Work Order ID 99863

Item Name: Crosstube Aft

DRAWING NO. D206-667-243	TITLE CROSSTUBE ASS'Y (206L HIGH AFT)	REV. C	DART AEROSPACE LTD ENGINEERING ORDER		D.E.O. NO. D206-667-243-C-1	SHEET NO. SHEET 1 OF 1	SCALE NTS
DRAWN 90	CHECKED ASS	MFG. APPR. RB	APPROVED MD		DE APPR. H		
DATE 11.07.15	DATE 11.07.20	DATE 11.07.21	DATE 11/07/21		DATE 11.07.21

A	NEW ISSUE	CP	11.07.15
REV.	DESCRIPTION	BY	DATE
DESIGN	9	DART AEROSPACE LTD HAWKESBURY, ONTARIO, CANADA	
DRAWN	9		
CHECKED	ASS	DRAWING NO.	REV. A
MFG. APPR.	N/A	DSI 9565	SHEET 1 OF 1
APPROVED		TITLE	SCALE
DE APPR.		SUPPORT INSTALLATION CHANGE	NTS
DATE	11.07.15	COPYRIGHT © 2011 BY DART AEROSPACE LTD THIS DOCUMENT IS PRIVATE AND CONFIDENTIAL AND IS SUPPLIED ON THE EXPRESS CONDITION THAT IT IS NOT TO BE USED FOR ANY PURPOSE OR COPIED OR COMMUNICATED TO ANY OTHER PERSON WITHOUT WRITTEN PERMISSION FROM DART AEROSPACE LTD.

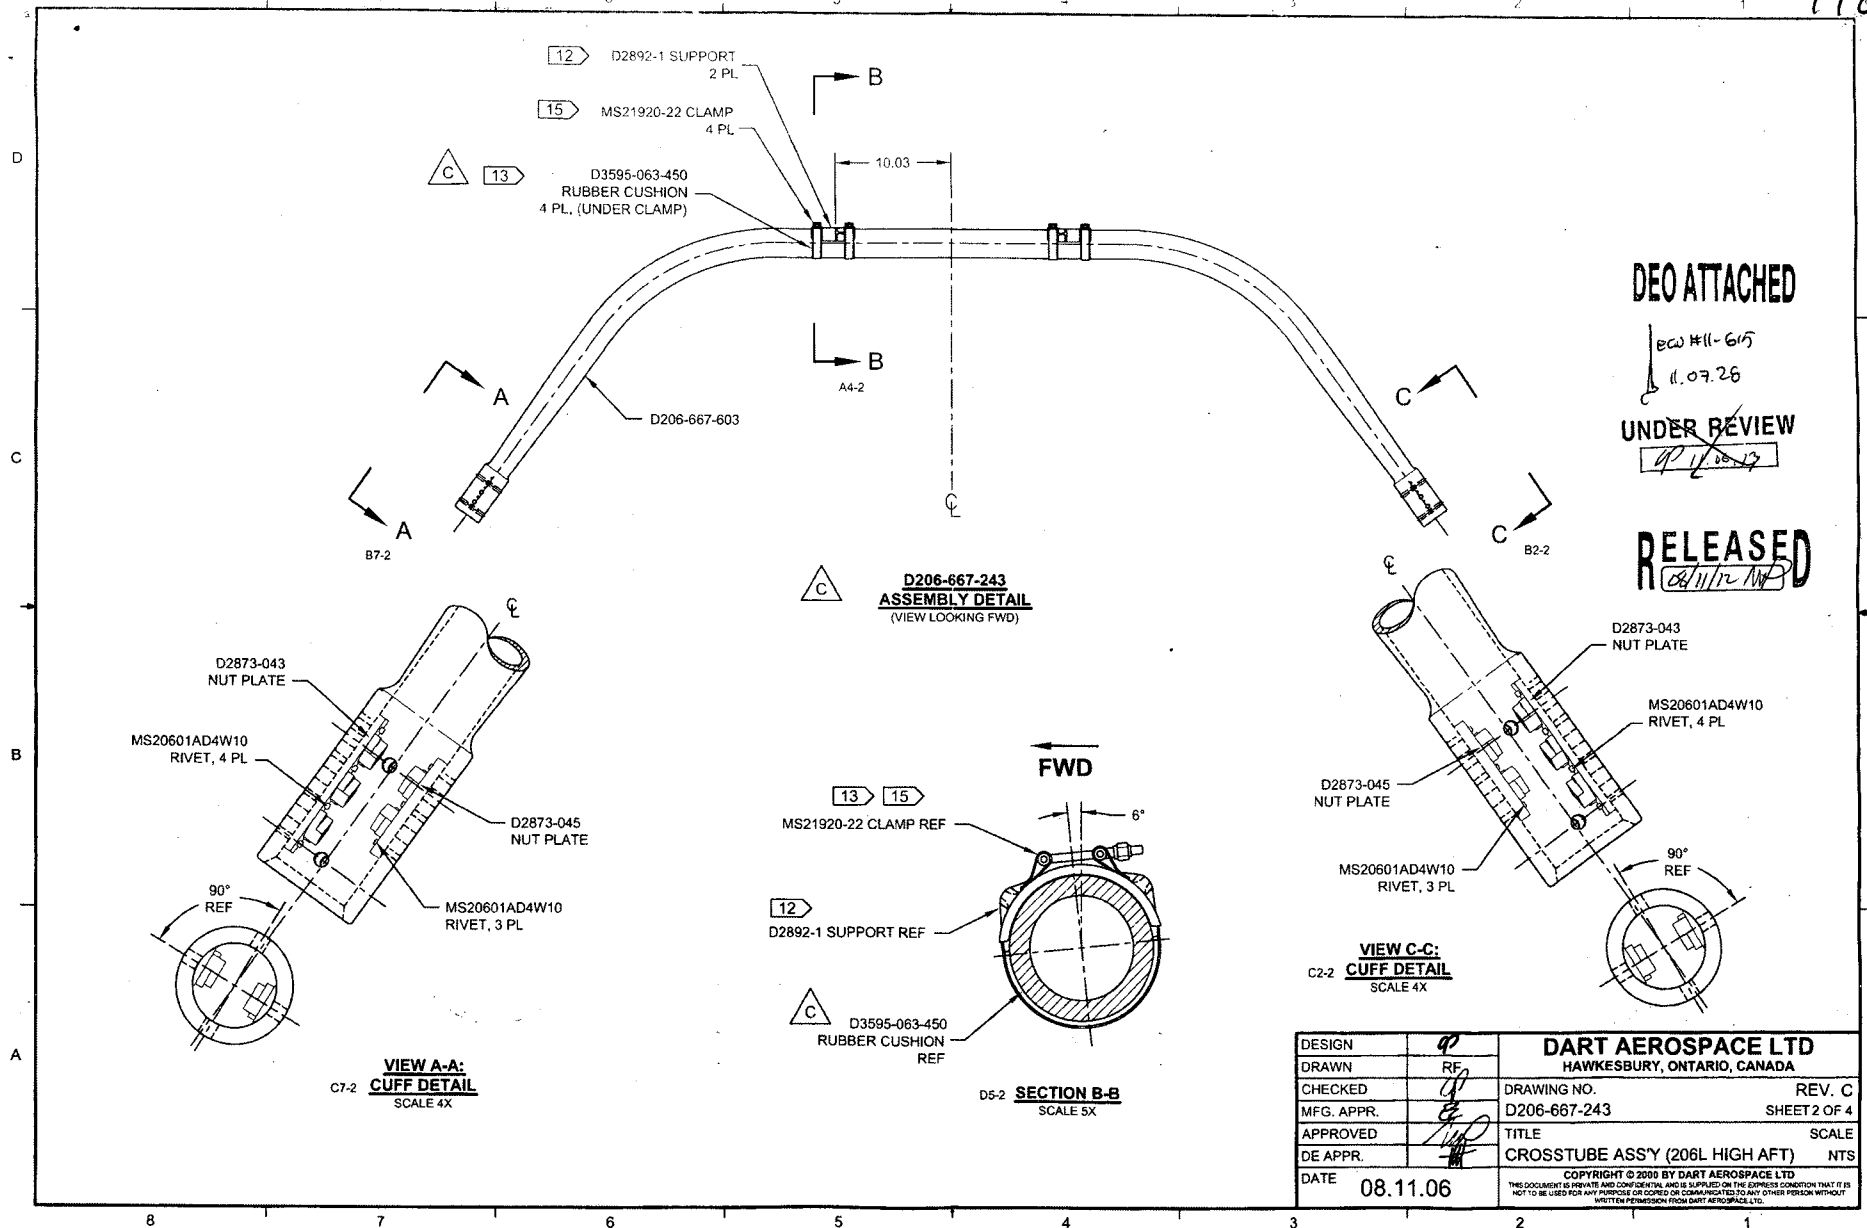
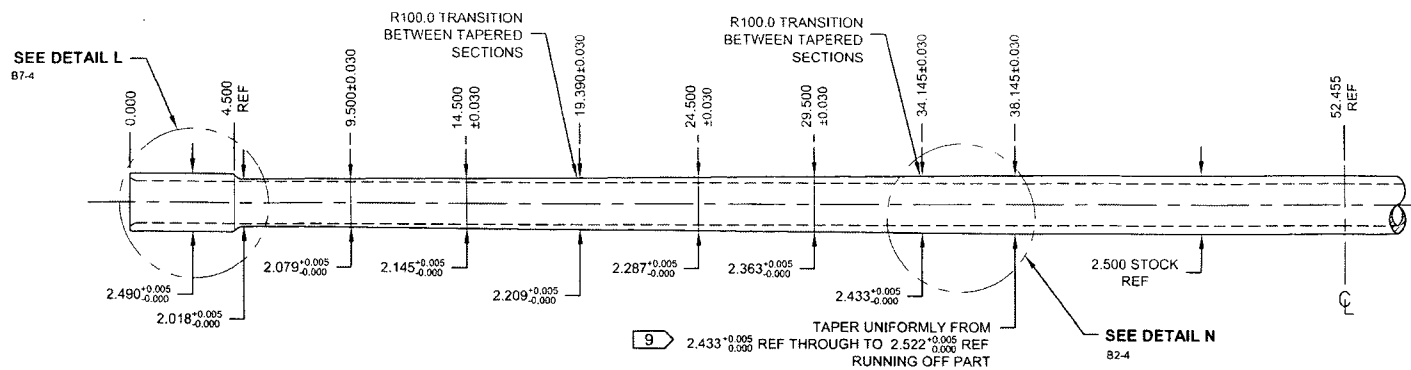
REPLACE MAGNOBOND WITH PROSEAL.

NOTE 12 & 15, SHEET 1 IS AMENDED AS FOLLOWS:

- 12) TO INSTALL D2892-1 SUPPORT: ABRASE MATING SURFACE OF SUPPORT AND CROSSTUBE WITH 180-GRIT SANDPAPER AND REMOVE RESIDUE WITH MEK (OR EQUIVALENT). APPLY A 0.04" TO 0.07" THICK LAYER OF PROSEAL 890 CLASS B-2 (OR AMS-S-8802 CLASS B-2) SEALANT TO MATING SURFACE OF SUPPORT.
- 15) TORQUE CLAMPS 80 TO 100 IN-LB. ENSURE AT LEAST 1.5 THREADS SHOWING IN SAFETY AND THAT NUT HAS NOT BOTTOMED-OUT AFTER TORQUING. **PRIOR TO PACKAGING, RE-CHECK TORQUE ON CLAMPS AFTER PROSEAL 890 SEALANT HAS CURED FOR 72 HOURS.**
